LI MEADOW

ADMINISTRATIVE SUBDIVISION PLAN NO. 620230100

No. 620230100

Completed: 6-14-2024

Figure 3 – Administrative Subdivision Plan

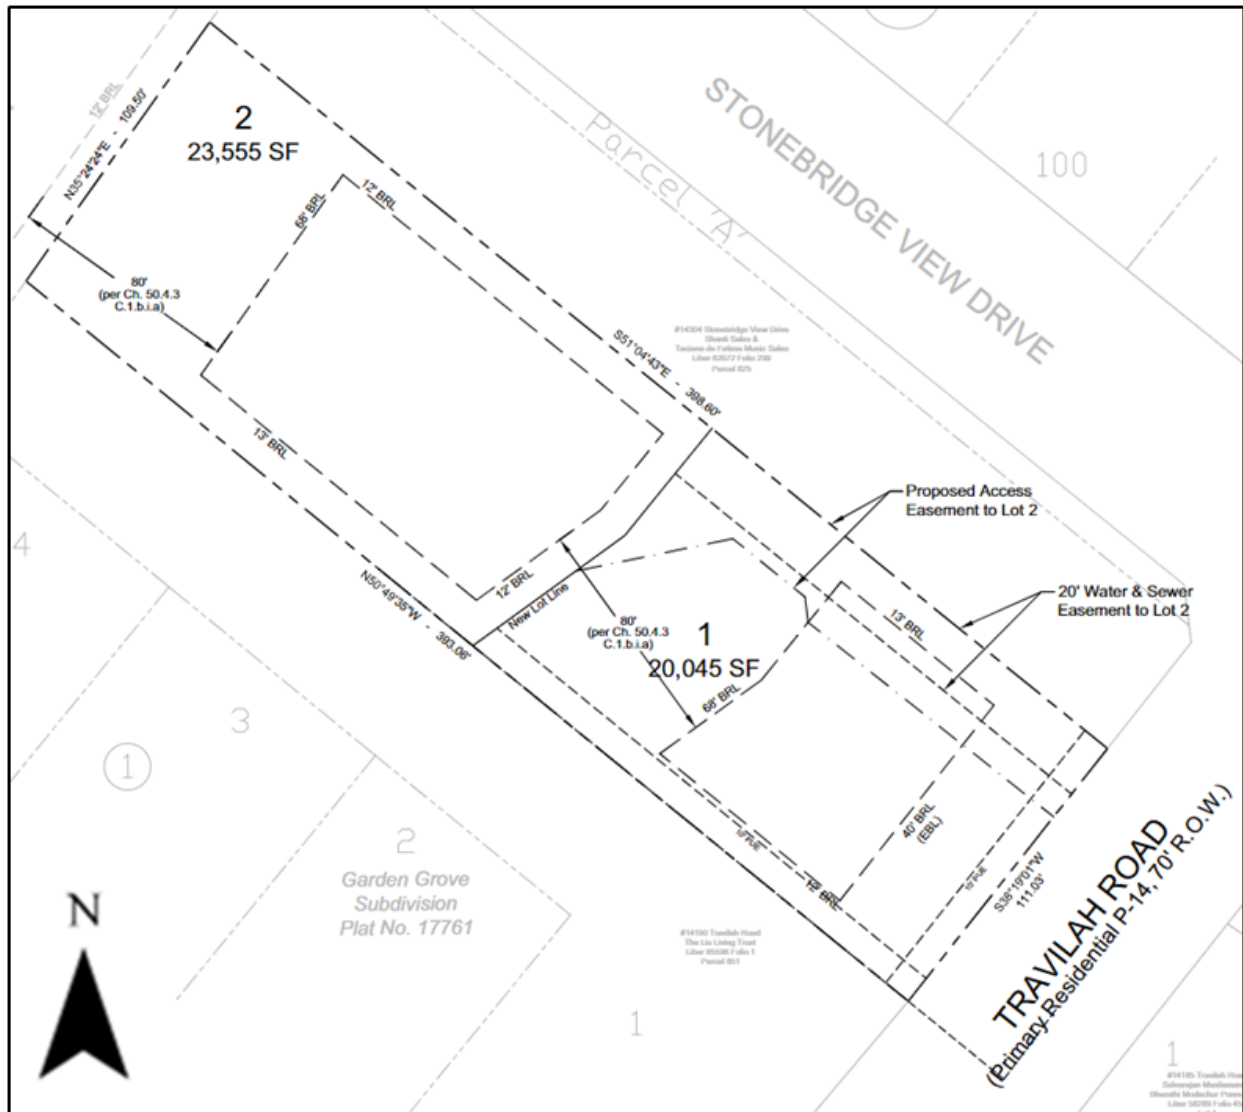
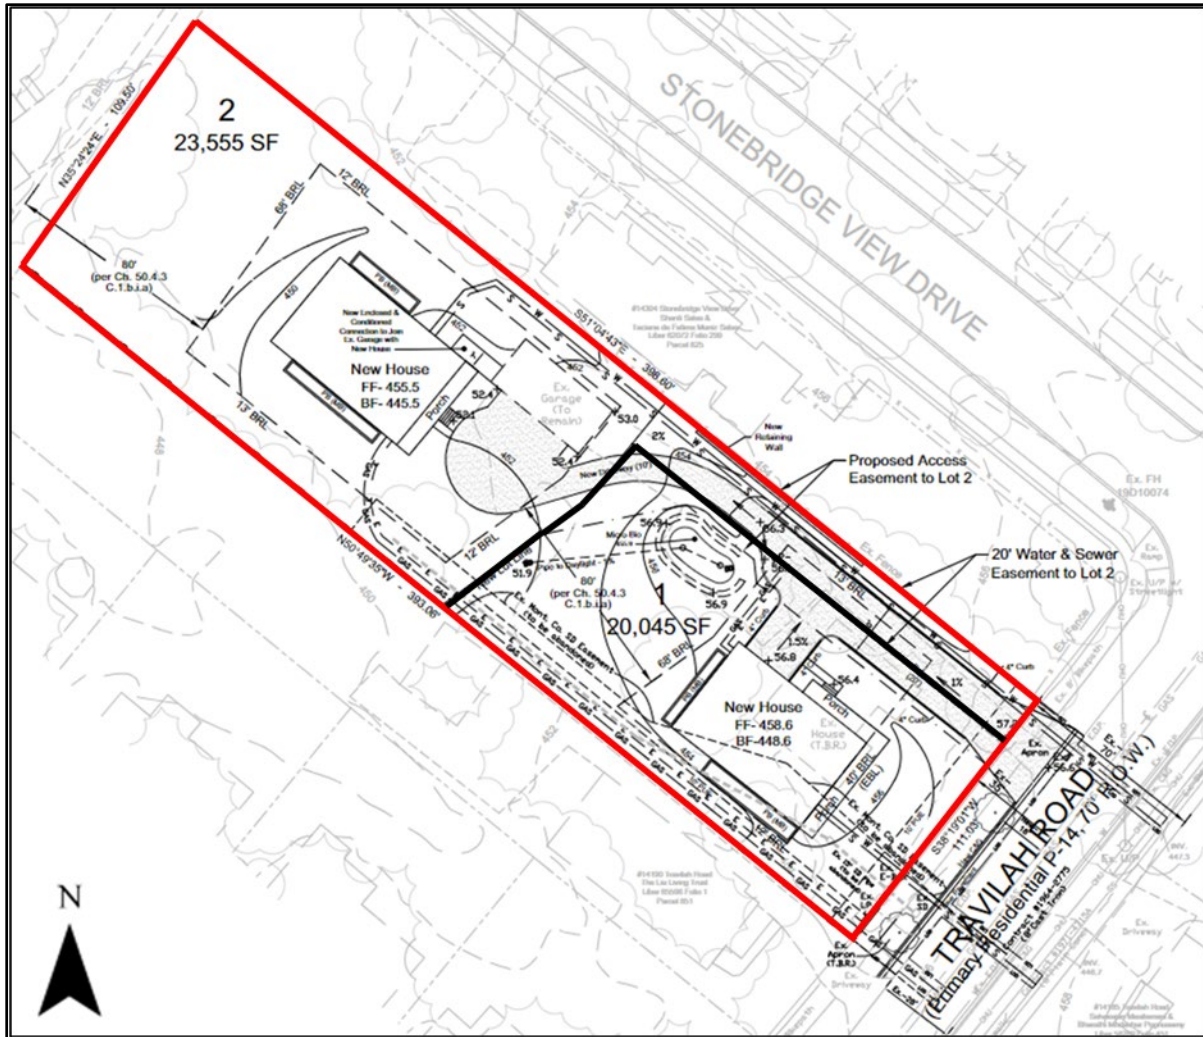
17. Before submittal of the Certified Administrative Subdivision Plan, the Applicant must make the following changes:
 - a) Show resolutions and approval letters on the certified set.

- b) Include the approved Fire Department Access plan in the certified set.
 - c) Update the data table to match the Staff Report.
 - d) Revise the LOD to reflect additional frontage improvements.

DETAIL PLAN VIEW: FRONTAGE IMPROVEMENTS
1"=20'

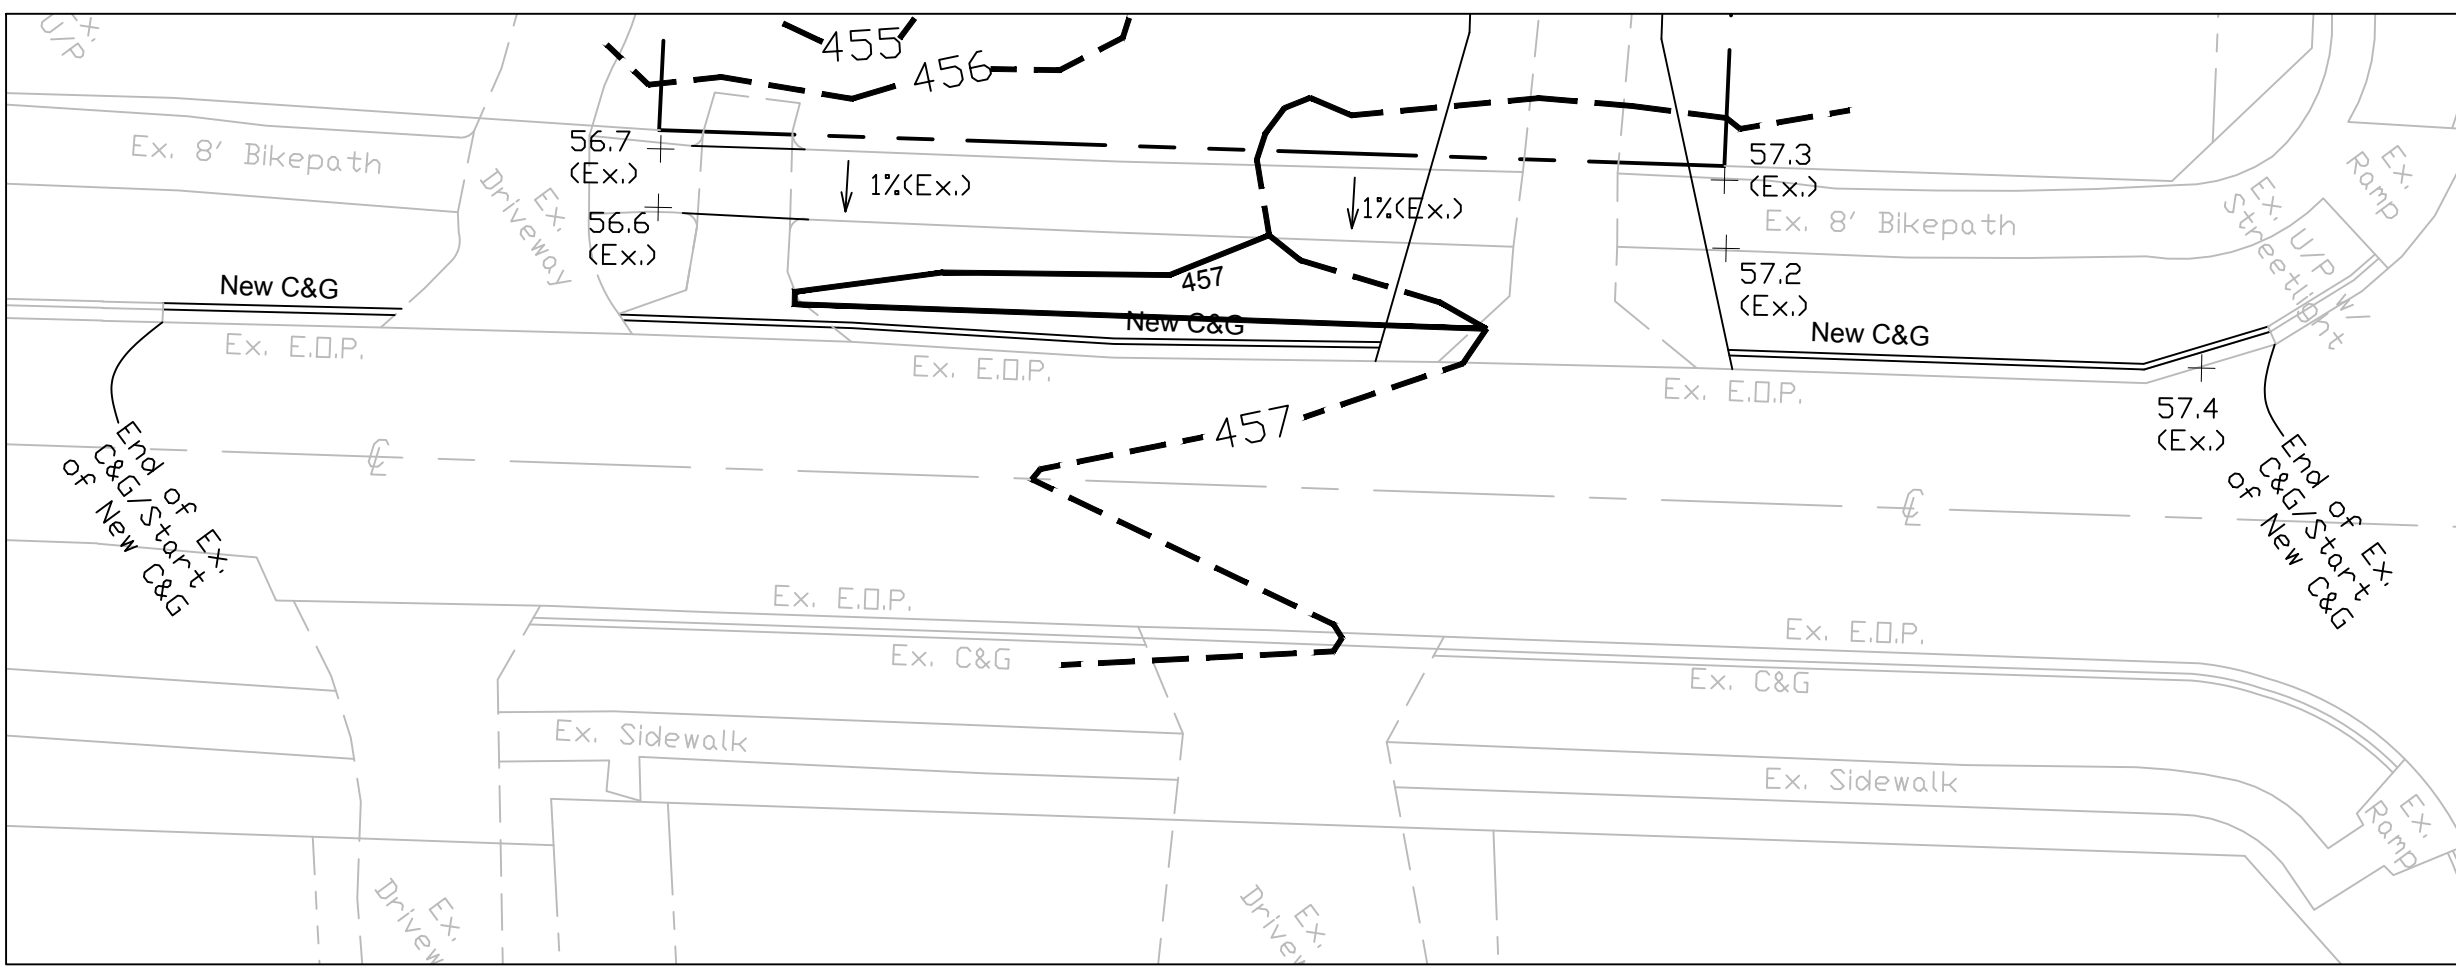
MCDOT also reviewed the Applicant's storm drain study and determined that the Applicant shall extend the curb and gutter in both directions to connect to the existing curb and gutter to the west of the Subject Property and to the east towards the intersection of Travilah Road and Stonebridge View Drive (Attachment B). The storm drain analysis was reviewed and is acceptable to MCDOT. The proposed removal of storm drain, and addition of curb and gutter will not adversely affect the downstream system. Therefore, no improvements are needed to the downstream public storm drain system for this plan. Tree planting within the public right of way must be coordinated with DPS Right-of-Way Plan Review Section.

2. At the right-of-way permit stage, provide detailed topographic information along the property frontage where the proposed curb ties into existing grade.
